VIRGINIA ELECTRIC AND POWER COMPANY  
RICHMOND, VIRGINIA 23261

**VIRGINIA ELECTRIC AND POWER COMPANY**  
**NORTH ANNA POWER STATION UNITS 1 AND 2**  
**INSERVICE INSPECTION PROGRAM RELIEF REQUESTS**

NORTH ANNA UNIT 1  
RELIEF REQUEST NDE-19

**NORTH ANNA UNIT 2**  
**RELIEF REQUEST NDE-19**

Sketch #10

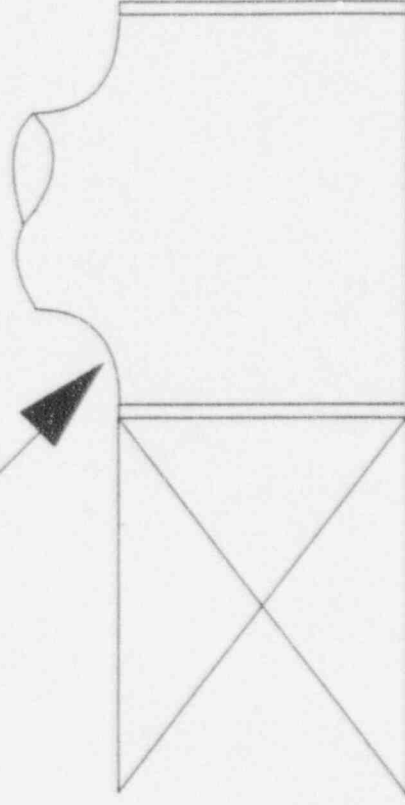
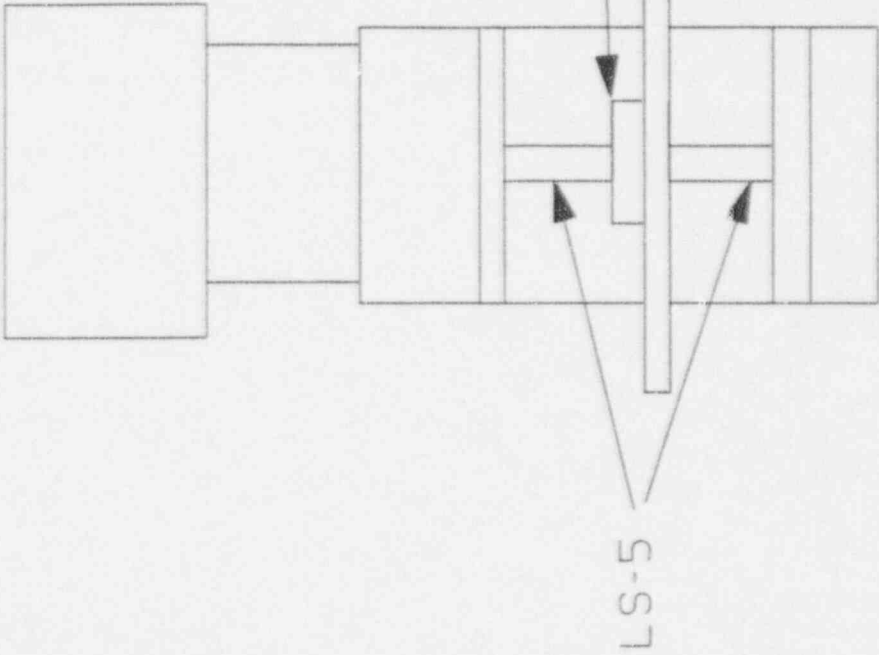
2-CH-1 93 VALVE TEE  
WELD 22
